157-161 BURNLEY STREET, RICHMOND MIXED-USED DEVELOPMENT

Outline Urban Design Review

Proposed Mixed-Use Development, 157-161 Burnley Street, Richmond *(amended plans)*

To: Lara Fiscalini
From: Mark Pisani
Date: 29 July 2020

TP-601

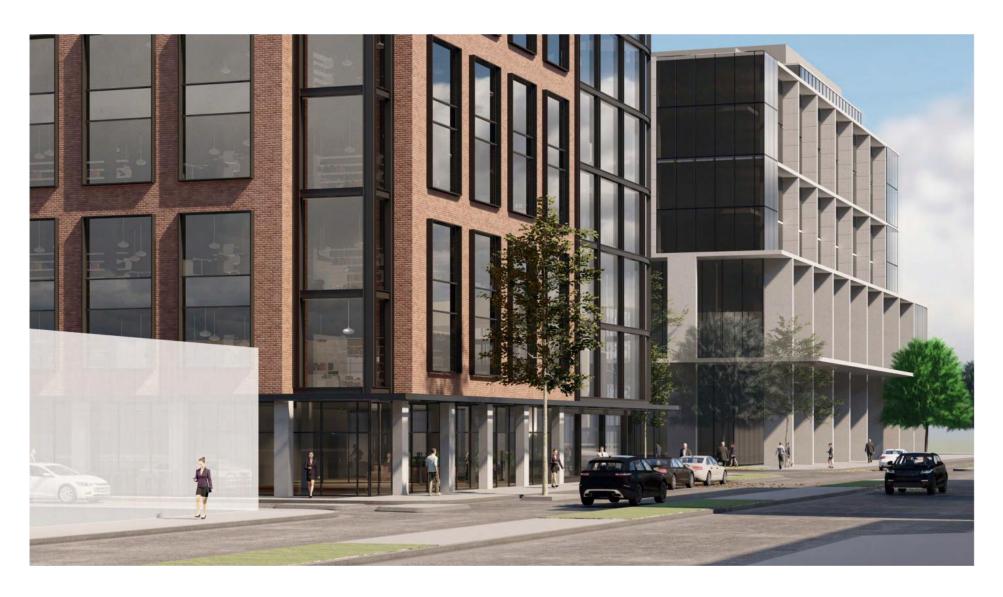
Through assessment of the visual implications illustrated by the perspective renders (TP-601, 602 and 603), I consider this approach acceptable given that:

- The white ground floor columns are quite deep, with the glazing set-in, revealing their size and provide depth in the ground floor frontage;
- They approximately align with the brick facades above, indicating structuring continuity.

However, in the Ground Floor Plan, these columns appear to be external to the glazing system, not integral with it, and are therefore perhaps cosmetic in nature.

While accepting the 1m set in at ground floor level, and the general approach to retaining substantial columns at ground floor level, I recommend further detail design consideration of these columns to ensure that they appear as solid, substantial and integral parts of the façade, to ensure the brickwork above has strong visual mass and 'groundedness'.

Figure 02: Amended proposal, reflecting more stable, robust, squat proportions.

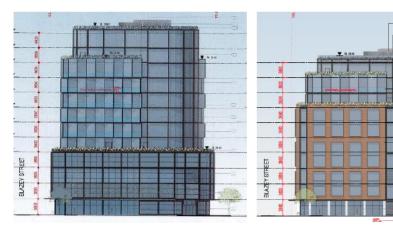
The reduced height of 10 storeys, couple with higher street walls of 7 storeys, give the building a more solid, robust and 'squat' proportion appearance, as shown below, which I consider to be more responsive and suited to the urban context.
